FINAL
ENVIRONMENTAL IMPACT STATEMENT
OF THE PROPOSED
GROUND BASED FREE ELECTRON LASER
TECHNOLOGY INTEGRATION EXPERIMENT
WHITE SANDS MISSILE RANGE
NEW MEXICO

January 1987

Prepared by:
U.S. ARMY CORPS OF ENGINEERS
HUNTSVILLE DIVISION
HUNTSVILLE, ALABAMA

Document Designation: Final EIS

Figure I-2. WSMR and Associated Co-Use Areas.

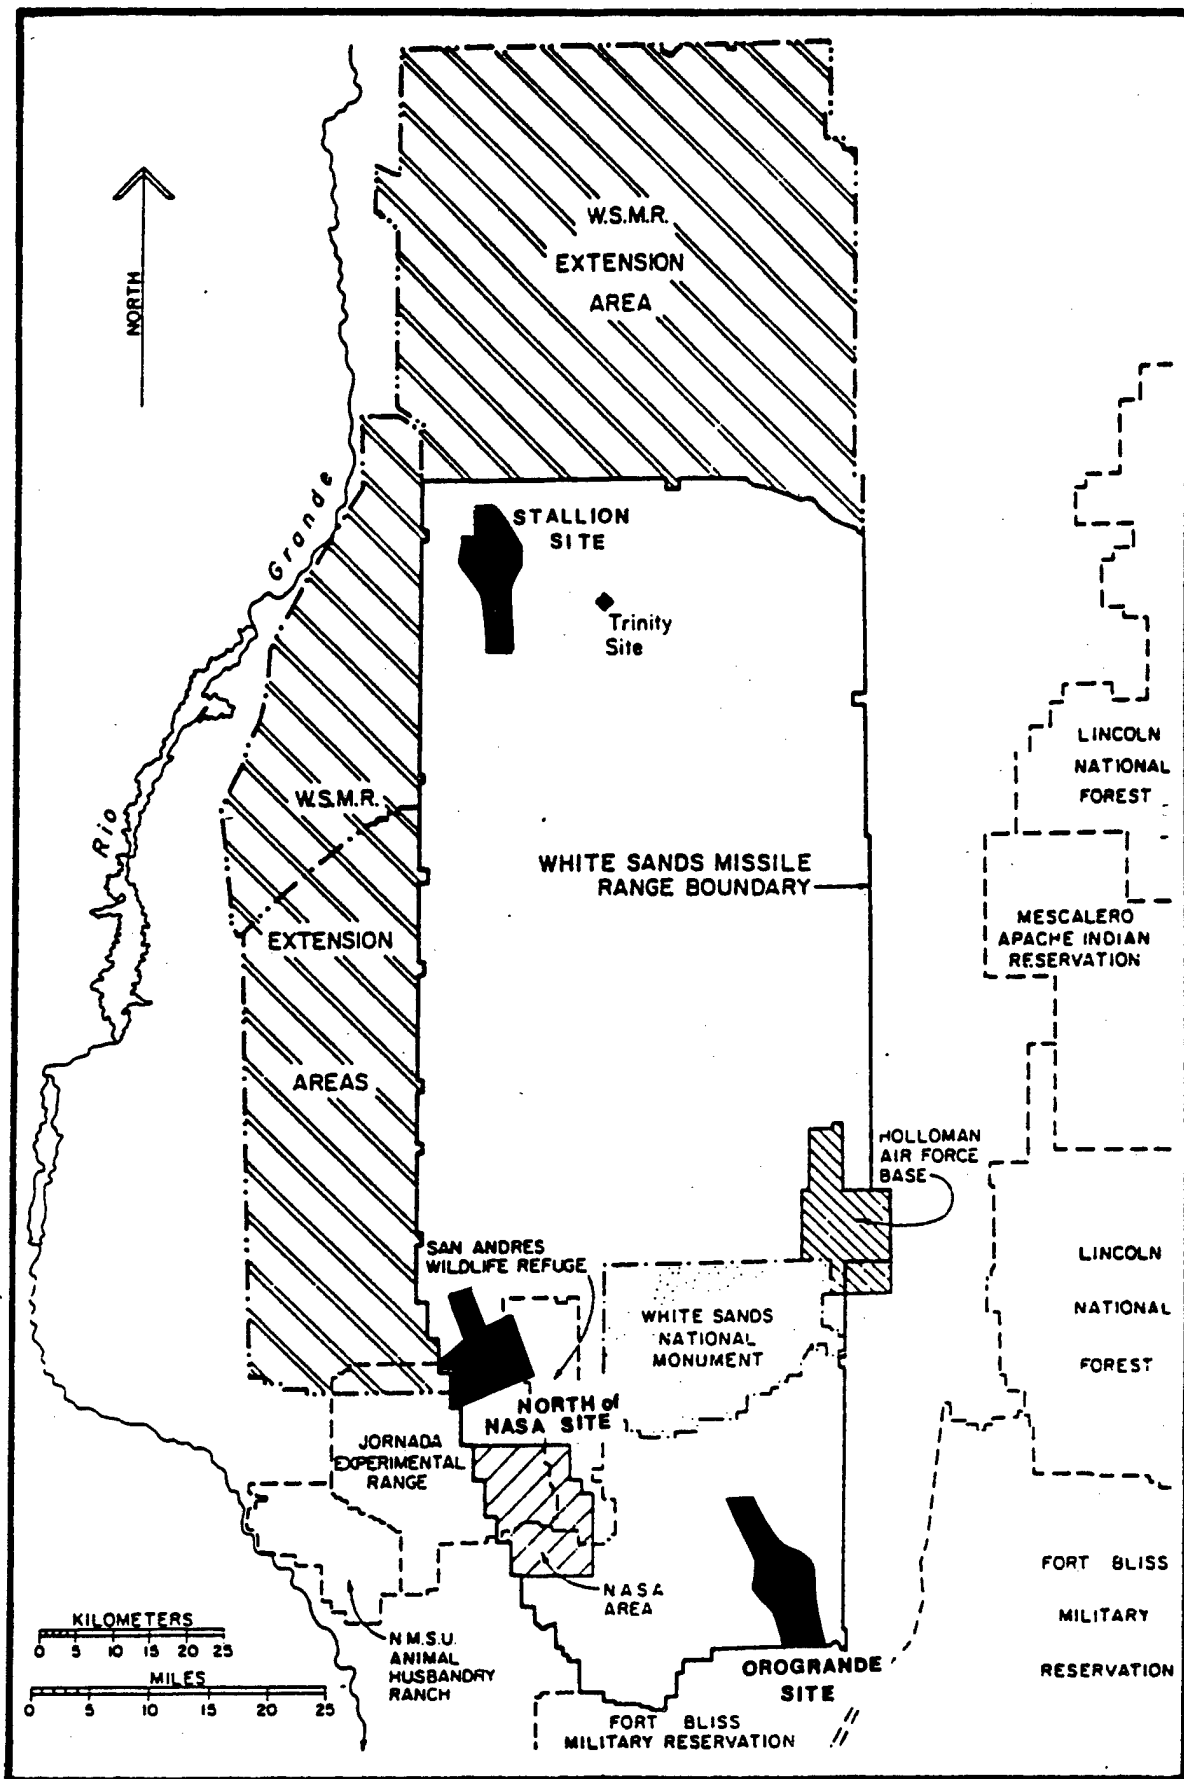
3. The title for Figure I-2 on page I-3 should be "WSNR and associated U.S. Department of the Interior co-use areas." The WSNR extension areas are covered by a memorandum of understanding (MOU) dated February 16, 1973, between the Department of the Army and the U.S. Department of the Interior (BLM and WSNR).

W-1.3 This correction has been made to the indicated figure (Figure I-2).

Figure I-4. GBFEL-TIE Facility Orientation at Stallion Candidate Site.

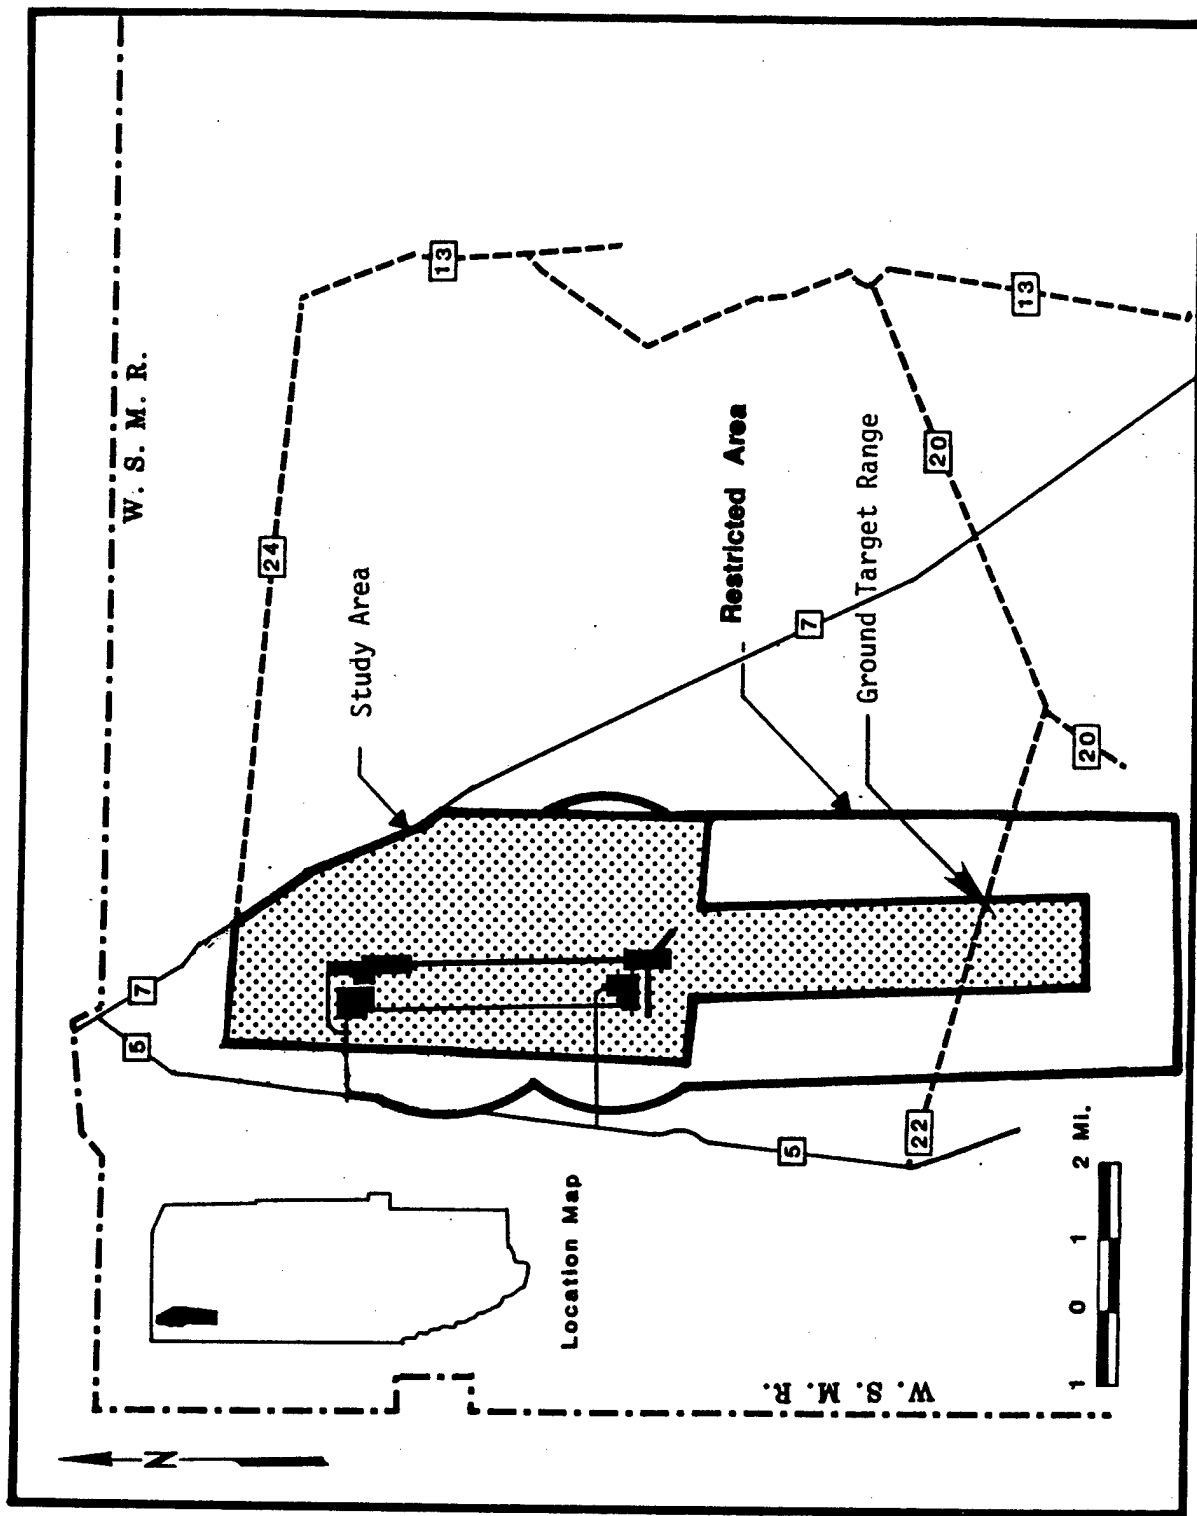
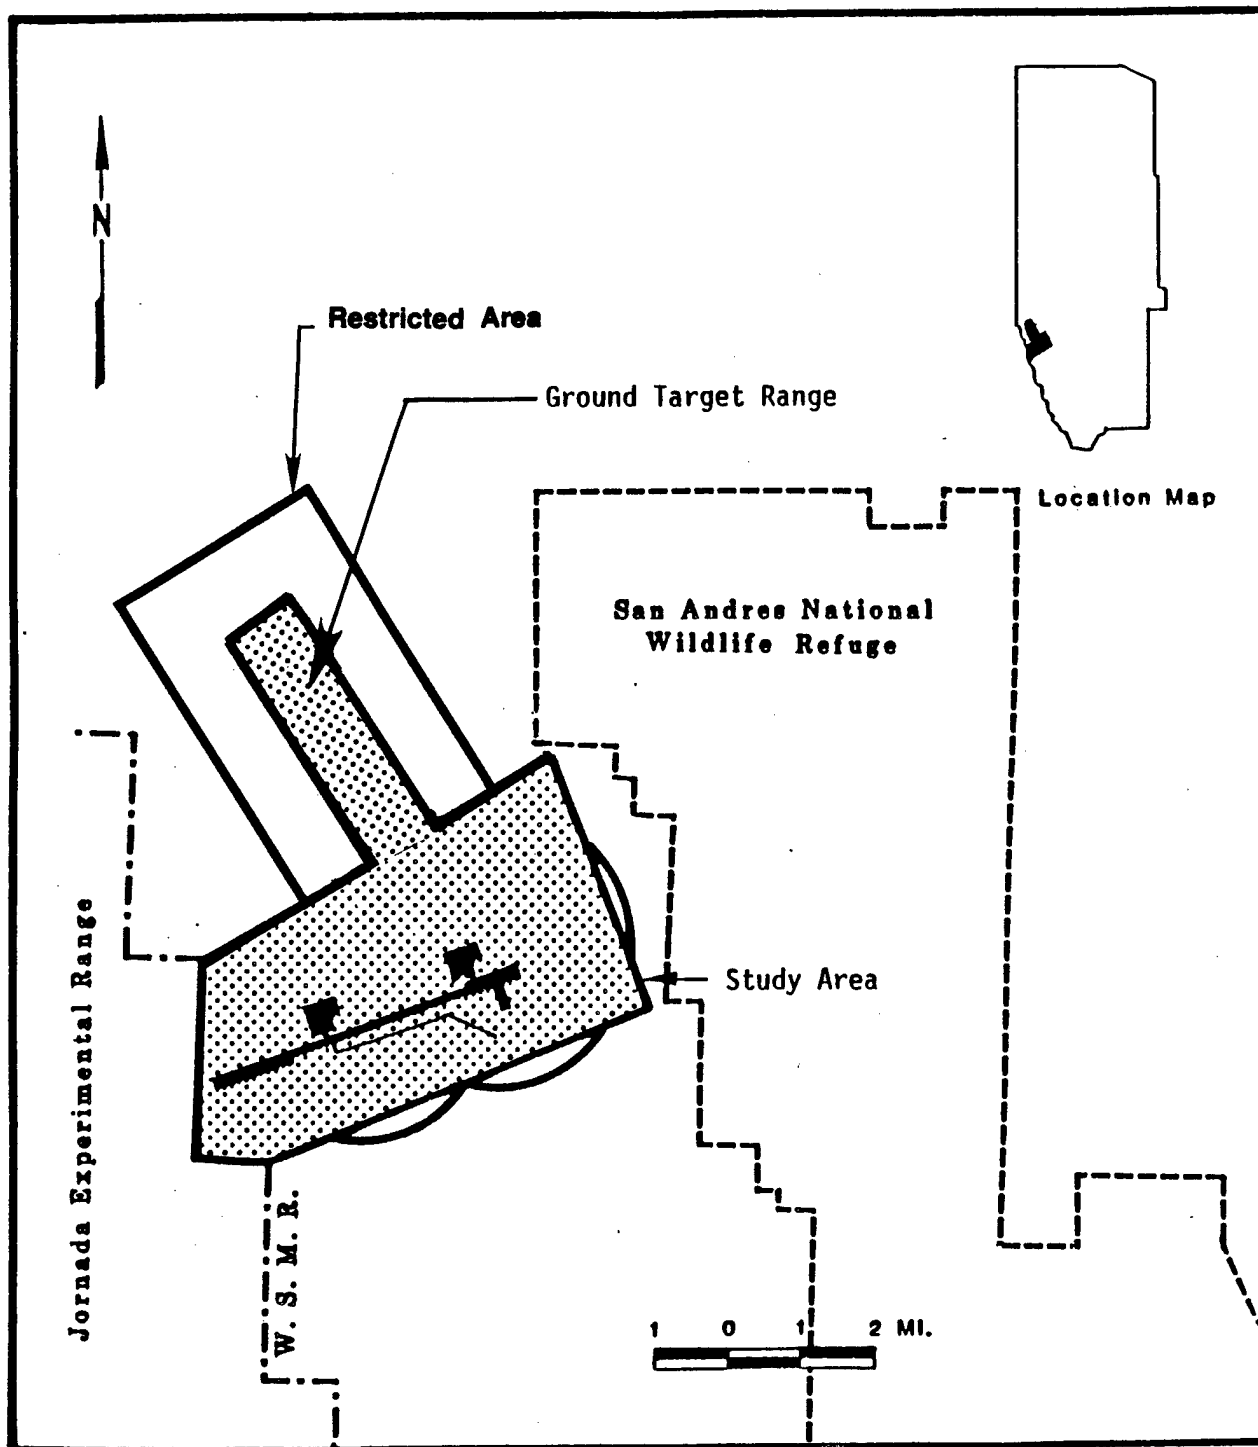
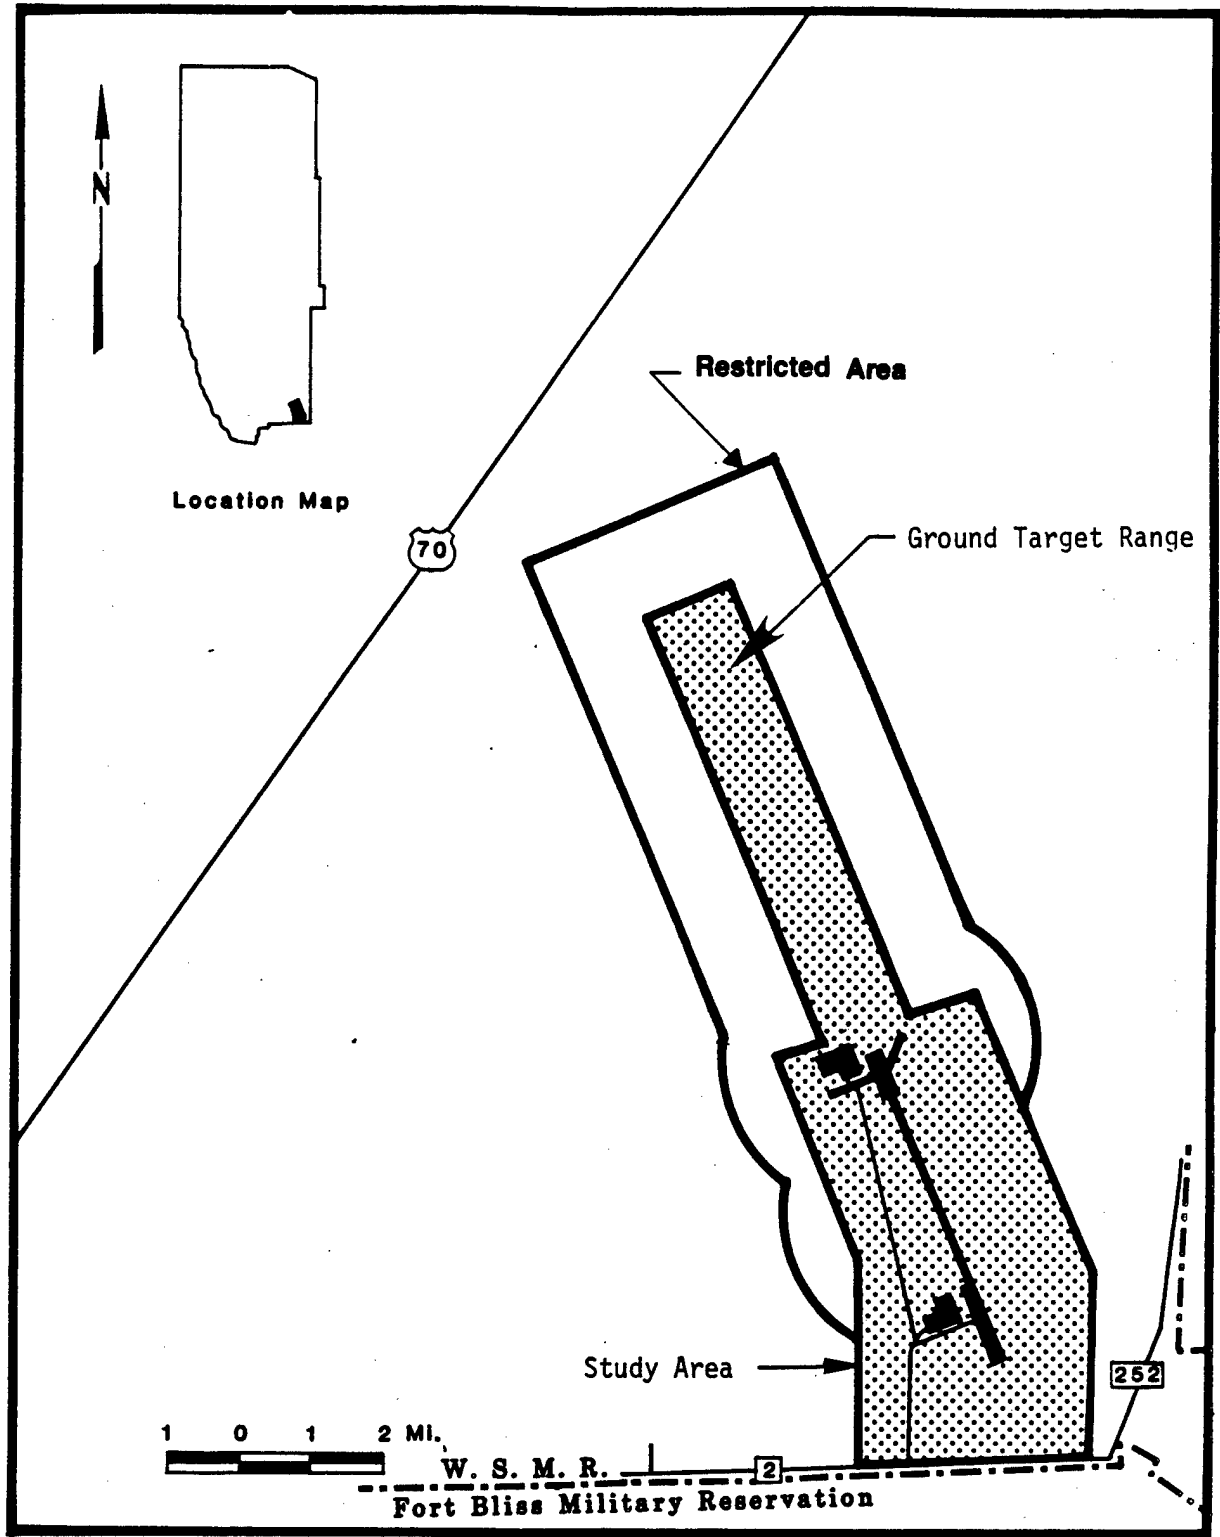
- c. Page 1-5 through 1-9: The land area descriptions given in paragraph D.1. on page 1-5 are different than those shown in Figure 1-4, 1-5 and 1-6. This must be corrected.
